# HENAN XINXIANG 24MW BIOMASS BASED COGENERATION PROJECT

| <b>Report Title</b>        | VCS Verification Report for Henan Xinxiang 24MW Biomass based Cogeneration Project                                                                                                                                                                                   |                                       |                                     |
| <b>Date of Issue</b>       | 04-09-2013                                                                                                                                                                                                                                                           |                                       |                                     |

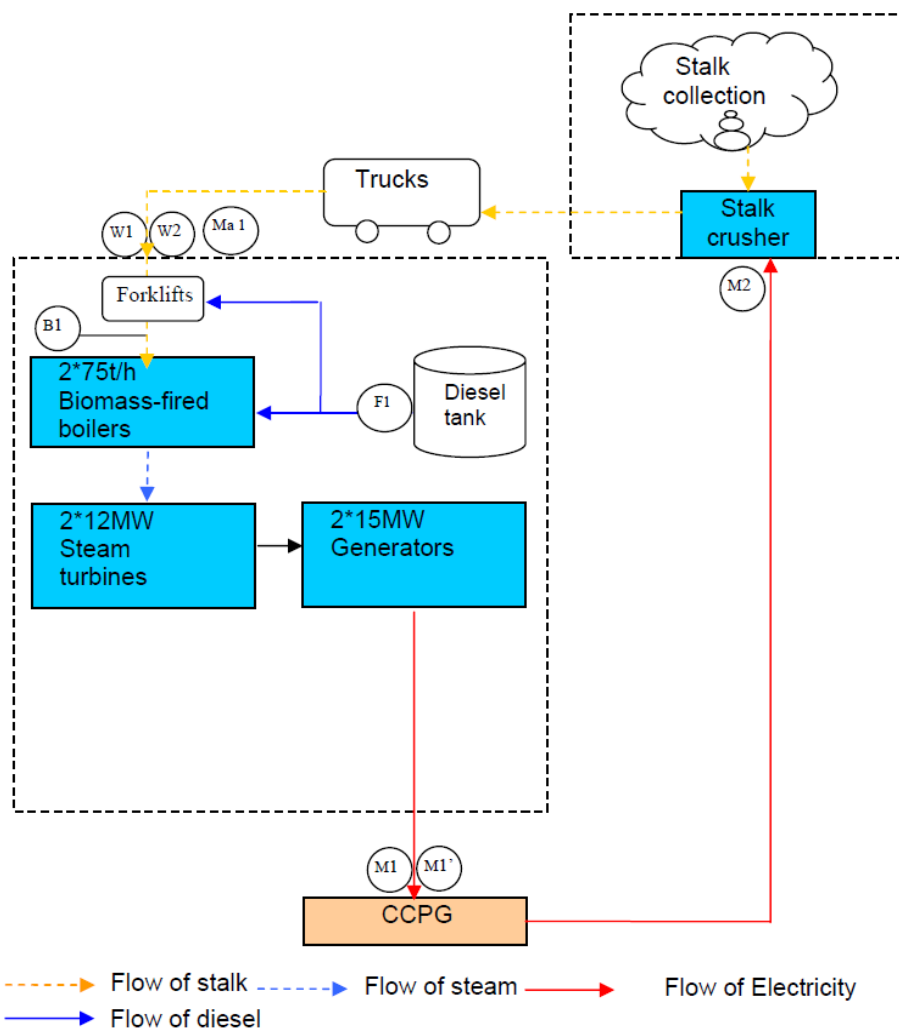
|      |                                                                                                                                                                                                                                                                  |                | response                                                                                                                                                                                                                                                                                                                                                                                                                                                                                                                                                                                                                                                                                                                                                                                                                                                                                                                                                                                                                                                                                                                                                                                                                                                                              | conclusion                                                                                                                                                                                                                                                                                                                                                                                                                     |
|------|------------------------------------------------------------------------------------------------------------------------------------------------------------------------------------------------------------------------------------------------------------------|----------------|---------------------------------------------------------------------------------------------------------------------------------------------------------------------------------------------------------------------------------------------------------------------------------------------------------------------------------------------------------------------------------------------------------------------------------------------------------------------------------------------------------------------------------------------------------------------------------------------------------------------------------------------------------------------------------------------------------------------------------------------------------------------------------------------------------------------------------------------------------------------------------------------------------------------------------------------------------------------------------------------------------------------------------------------------------------------------------------------------------------------------------------------------------------------------------------------------------------------------------------------------------------------------------------|--------------------------------------------------------------------------------------------------------------------------------------------------------------------------------------------------------------------------------------------------------------------------------------------------------------------------------------------------------------------------------------------------------------------------------|
| CL 1 | It is found by checking the calibration records of M1 and M1' that the earliest date of calibration is 16 Nov. 2009, so no evidence is demonstrated that the monitoring data of them covering from 28 Oct. 2009 to 15 Nov.2009 is measured by calibrated meters. | MR<br>ER sheet | <p>According to Section 9.4.4.2, Paragraph 238 of Clean Development Mechanism Validation and Verification Standard (version 3.0),</p> <p>“If, during verification of a certain monitoring period, the DOE identifies that the calibration has been delayed and the calibration has been implemented after the monitoring period in consideration (i.e. the results of delayed calibration are available), the DOE may conclude its verification, provided the following conservative approach is adopted in the calculation of emission reductions:</p> <p>(a) Applying the maximum permissible error of the instrument to the measured values taken during the period between the scheduled date of calibration and the actual date of calibration, if the results of the delayed calibration do not show any errors in the measuring equipment, or if the error is smaller than the maximum permissible error; or</p> <p>(b) Applying the error identified in the delayed calibration test, if the error is beyond the maximum permissible error of the measuring equipment.”</p> <p>For this project, the calibration of M1 and M1' has been delayed for couple of days, but the results do not show any errors, therefore, the value of EGimport,y and EGexport,y measured by</p> | <p>It is verified according to VVS version 3.0 that the corrective action for the period from 28 Oct.2009 to 15 Nov.2009 is in line with the CDM requirement regarding delayed calibration.</p> <p>In addition the emission reduction covering the period from 16 Nov. 2009 to 22 Nov.2009 monitored by calibrated meter is deducted by maximal permission error, it is considered conservative.</p> <p>This CL is closed.</p> |

|  |  |  | M1 and M1' during 28/10/2009 (the scheduled calibration date) to 16/11/2009 (the actual calibration date) have been adjusted by applying the max permissible error of the meters (0.5%). |  |
